Access Compliance Report

Public Rights-of-Way

(Curb Ramps)

Intersection ID: 30561	Main Street: BUBBLING_BRANCH_LN	Cross Street: CIRCLEGREEN_DR	Location:	N
ADA ID: 32D9EFBCEF3B	Ramp Type: PerpDiag	Initial Pass/Fail: Fail	Overall Compliance: No	Severity Score: 37.5
Codes/Mitigation Info/Possible Solution		Field Measurements/Component Compliance

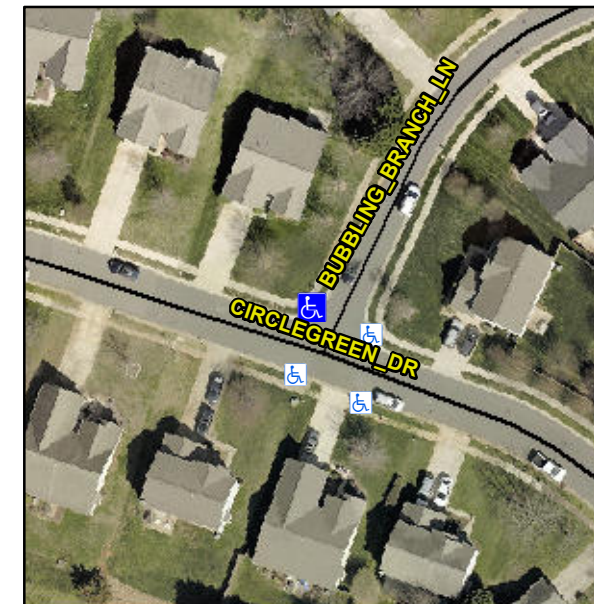
R304.2.2, R304.5.3

Compliance	Description	Data	Compliance	Description	Data
N/A	Ramp Length (in)	48.5	No	Ramp Slope (%)	9.6
Yes	Ramp Width (in)	48.0	No	Ramp XSlope (%)	10.7
N/A	Flare Type LT	N/A	N/A	Flare Type RT	N/A
N/A	Flare Slope LT (%)	N/A	N/A	Flare Slope RT (%)	N/A
N/A	Flare Traversable LT?	N/A	N/A	Flare Traversable RT?	N/A
N/A	Landing Length (in)	N/A	N/A	DWS Provided?	N/A
N/A	Landing Width (in)	N/A	N/A	DWS Contrast?	N/A
N/A	Landing Slope (%)	N/A	N/A	DWS Length (in)	N/A
N/A	Landing X Slope (%)	N/A	N/A	DWS Full Width?	N/A
N/A	Landing Curb? (Y/N)	N/A	N/A	DWS Offset (in)	N/A
N/A	Shared Landing?	N/A			
N/A	Gutter Ponding?	N/A	N/A	Gutter Slope (%)	N/A
N/A	Gutter Lip Ht (in)	N/A	N/A	Gutter X Slope (%)	N/A
N/A	Painted X Walk1?	No	N/A	Painted X Walk2?	No
	X Walk 1 Direction	To SW		X Walk 2 Direction	To SE
N/A	X Walk 1 Width (in)	N/A	N/A	X Walk 2 Width (in)	N/A
	X Walk 1 Slope (%)	3.3		X Walk 2 Slope (%)	5.7
	X Walk 1 X Slope (%)	8.2		X Walk 2 X Slope (%)	3.4

Remove & Replace Curb Ramp With Two New Directional Ramps or Equivalent.
